ADDENDUM TO THE CONTRACT

Last Chance Basin Well Field Generator Replacement Contract No. E14-112

ADDENDUM NO.: TWO

DATE ADDENDUM ISSUED: June 6, 2014

DRAWING NAME:		CITY AND BOROUGH OF JUNEAU LAST CHANCE BASIN WELL FIELD GENERATOR REPLACEMENT E14-112 CONSTRUCTION LAYOUT - TEMPORARY POWER
REF DWG(S):		
DRAWING NO.:		E12
		SHEET 17 OF 21

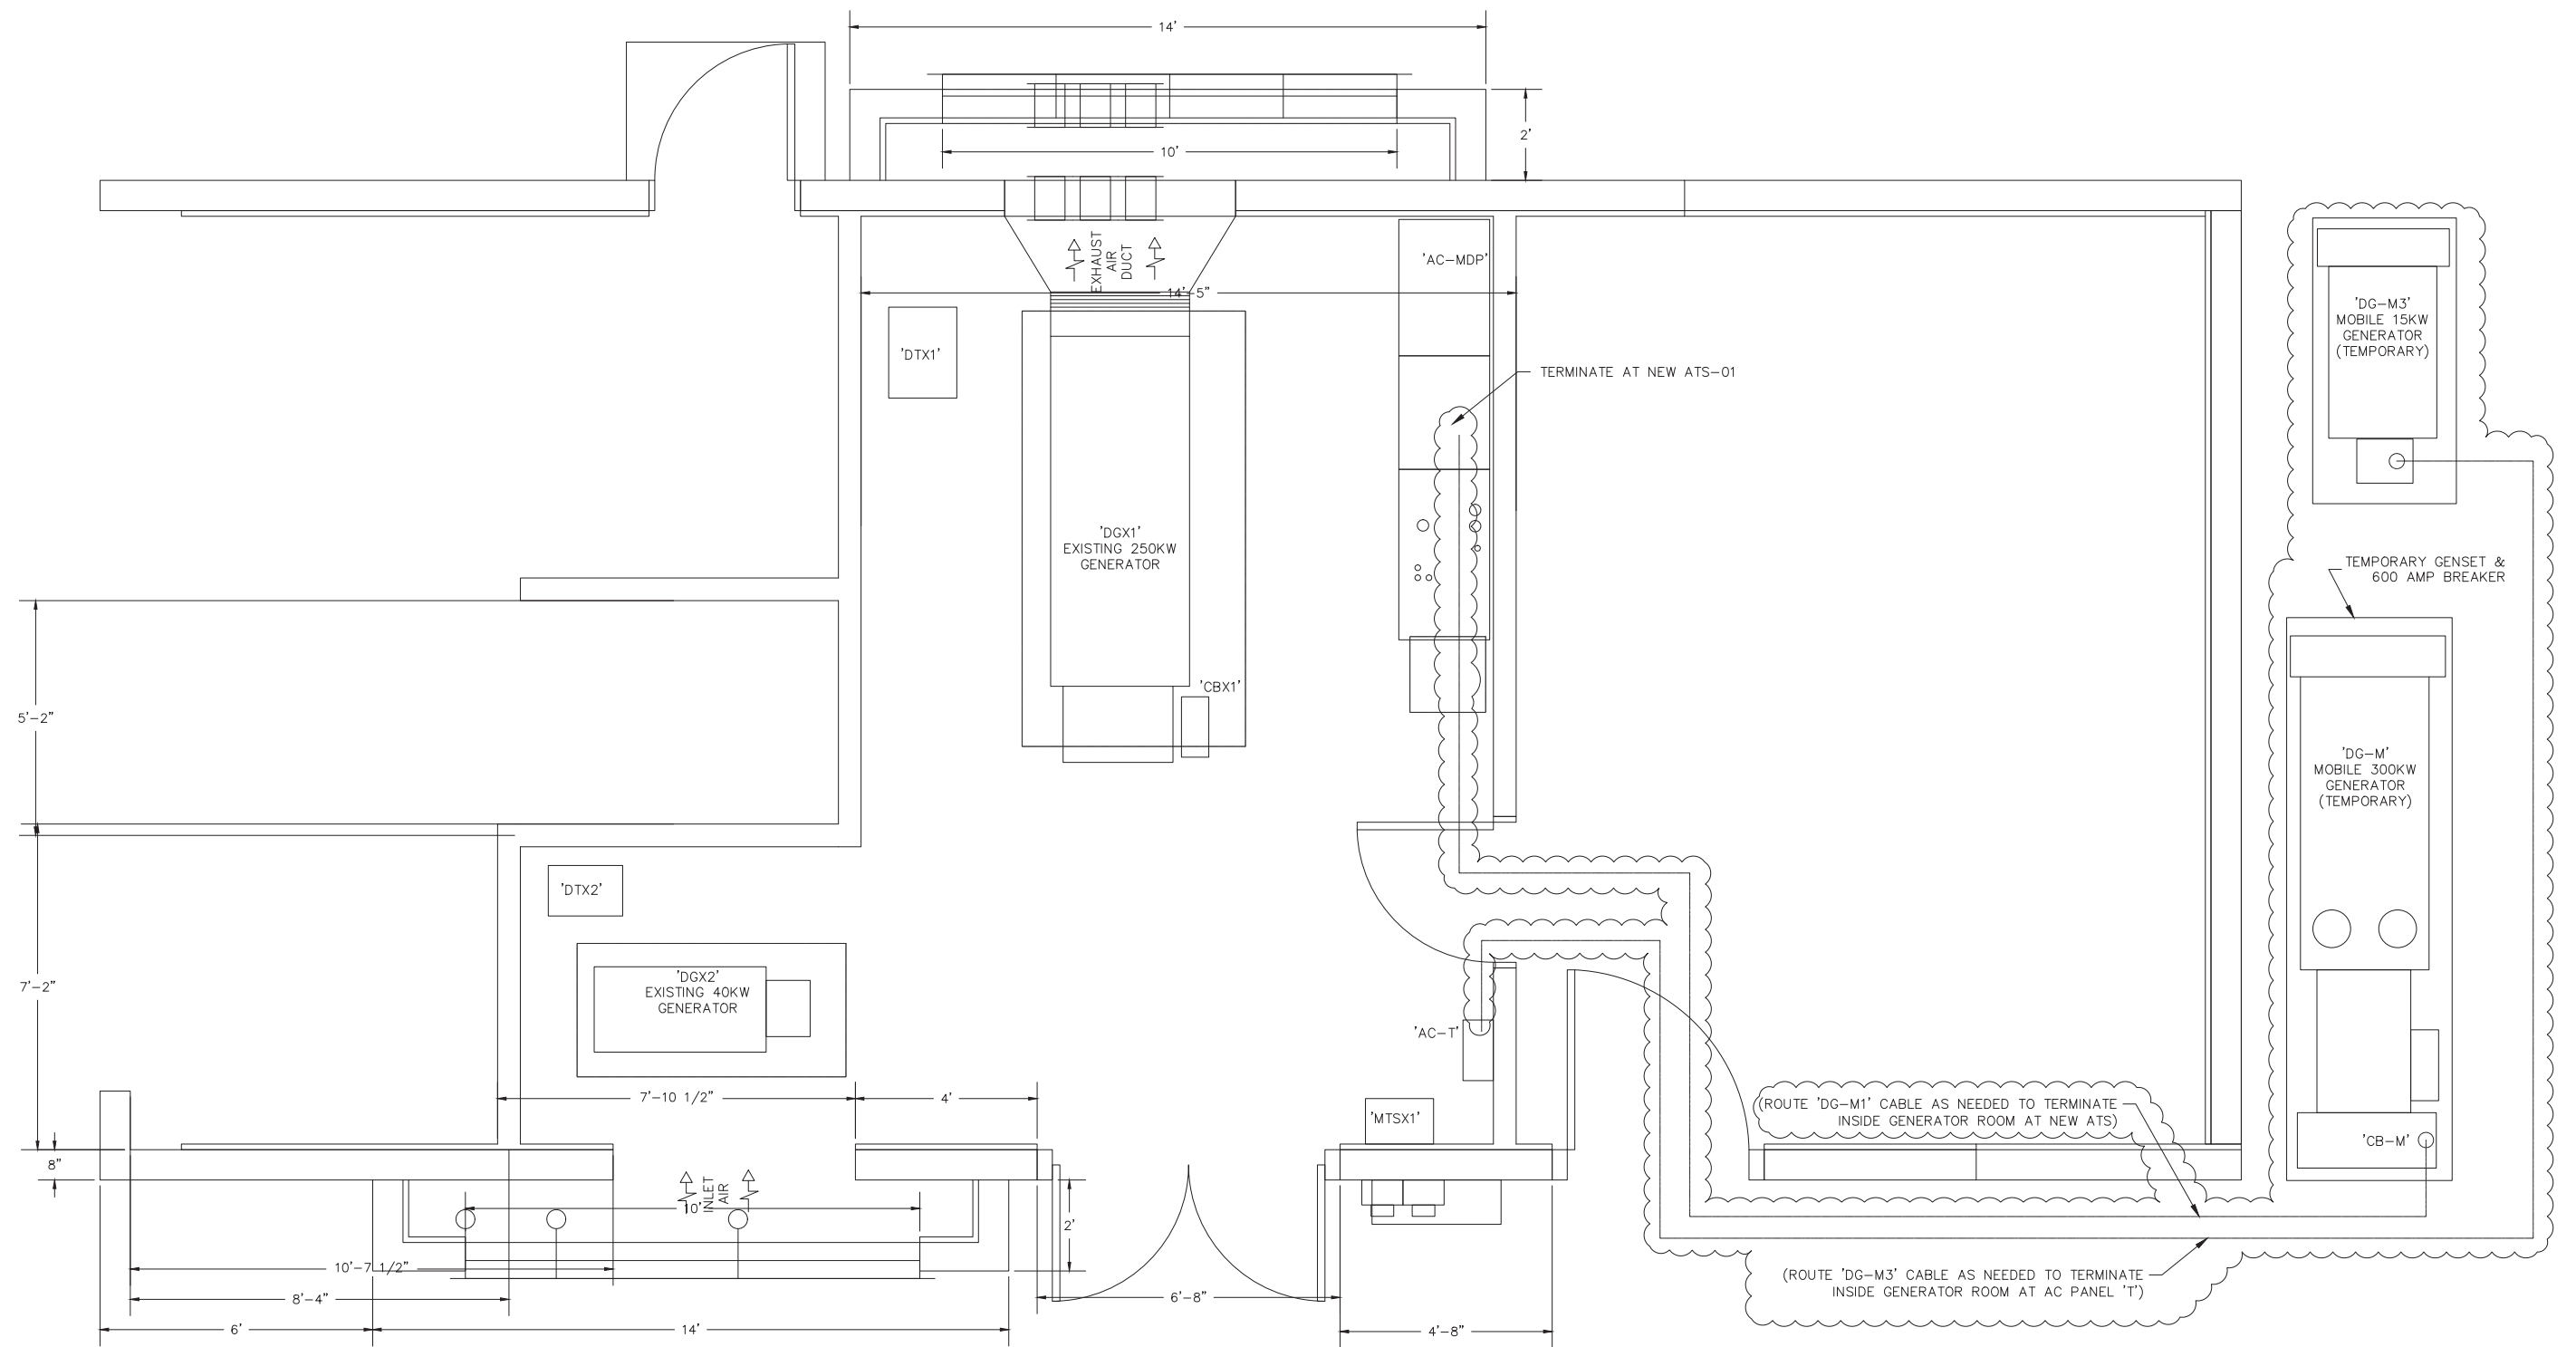
- Item No. 4: E1 – SHEET 6 of 21 - ONE-LINE DIAGRAM (DEMOLITION). **Delete** in its entirety and **replace** with the attached sheet E1 – SHEET 6 of 21 – ONE-LINE DIAGRAM (DEMOLITION).
- Item No. 5: E12 – SHEET 18 of 21 – CONSTRUCTION LAYOUT-TEMPORARY POWER. **Delete** in its entirety and **replace** with the attached sheet E12 – SHEET 17 of 21 – CONSTRUCTION LAYOUT- TEMPORARY POWER.

NO.	DRAWING NO./SHEET	REFERENCE DRAWING/DETAIL/PLAN/SECTION DESCRIPTION	DRAWING NAME:
			CITY AND BOROUGH OF JUNEAU
			LAST CHANCE BASIN WELL FIELD
			GENERATOR REPLACEMENT E14-112
			CONTROL SCHEMATIC
			e14.dwg
			REF DWG(S):
			DRAWING NO.: E14
			SHEET 19 OF 21

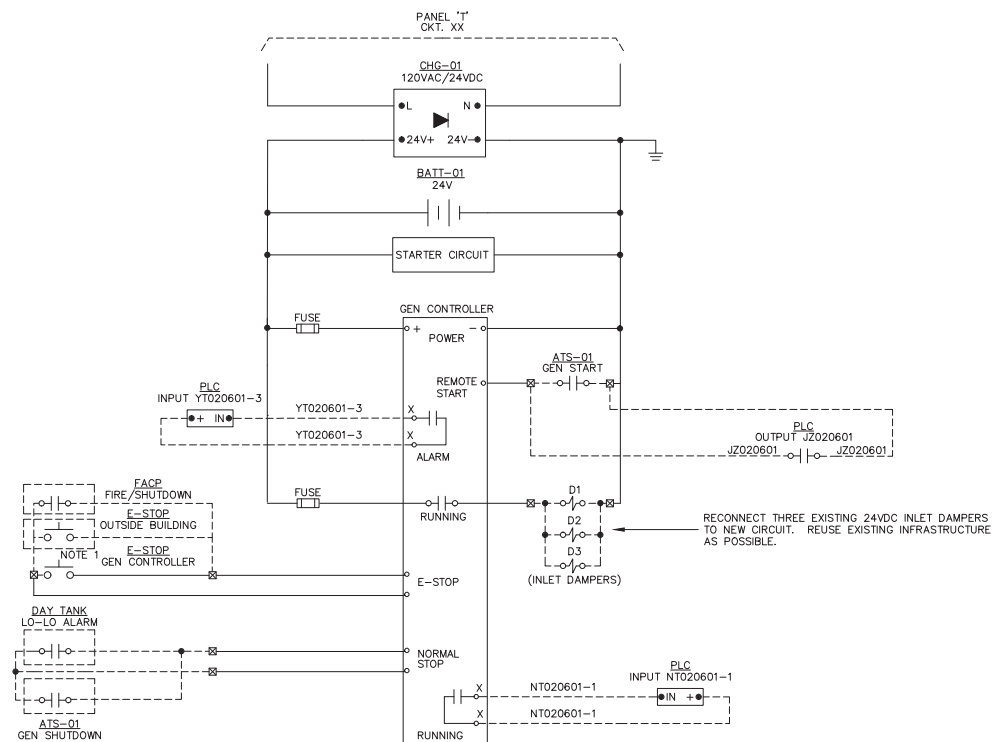
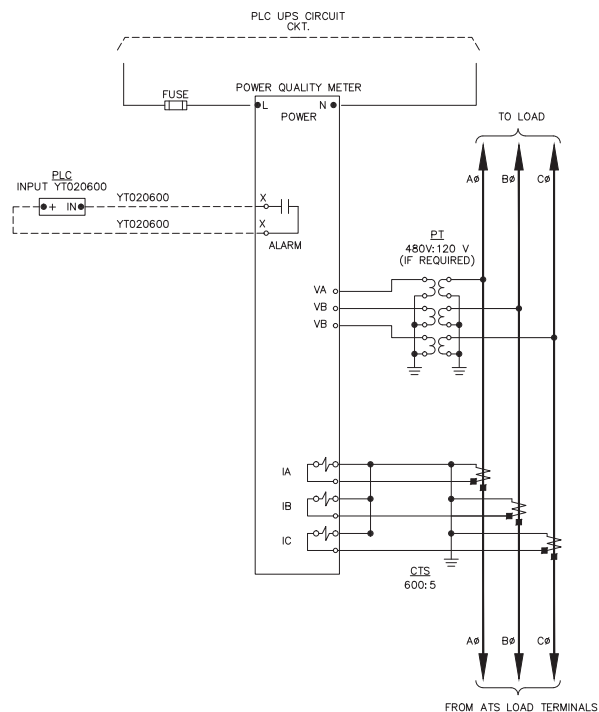
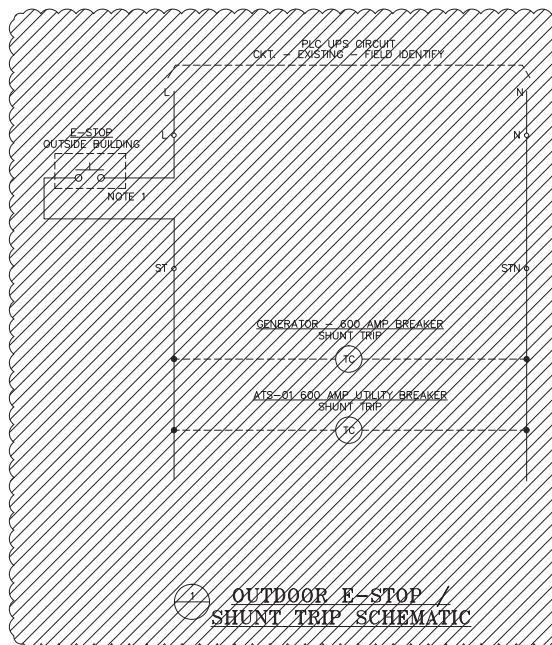
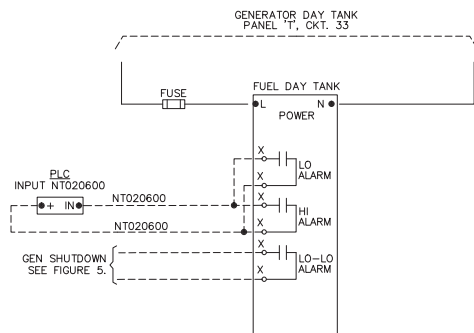
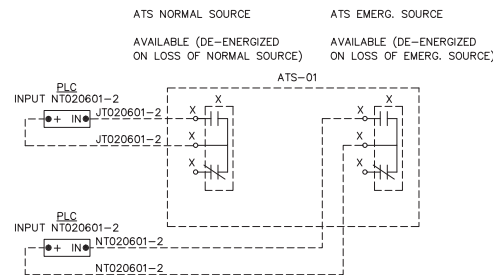
Item No. 7: E14 – SHEET 20 of 22 – CONTROL SCHEMATIC. **Delete** in its entirety and **replace** with the attached sheet E14 – SHEET 19 of 21 - CONTROL SCHEMATIC.
